Replacement Notes for : Super Sun

Installations Notes:

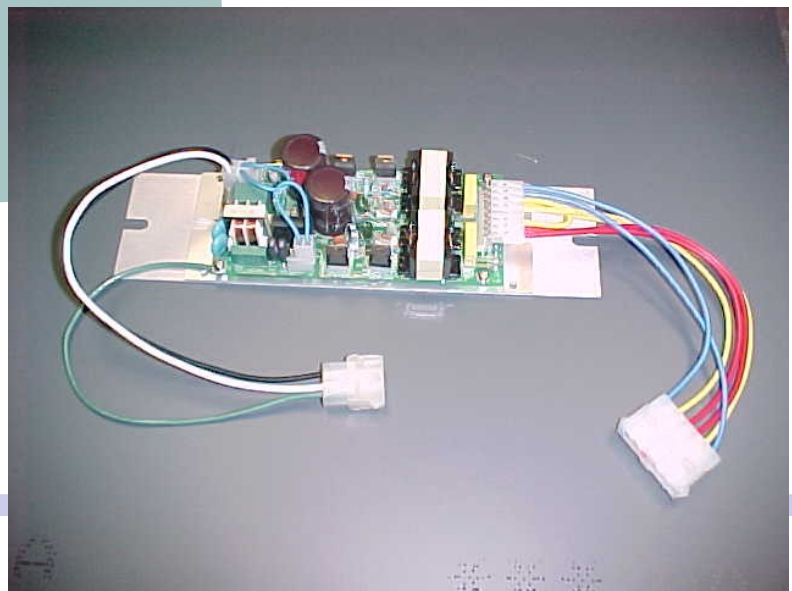
Super Sun ballast, pictured at left, is replaced by the FA100 ballast using adapter harnesses 3-3IN-SS for the input and 6-6OUT-SS for the output, as pictured below. The 9.5" x 2.5" extended mounting plate is included to match the mounting footprint of the original ballast.
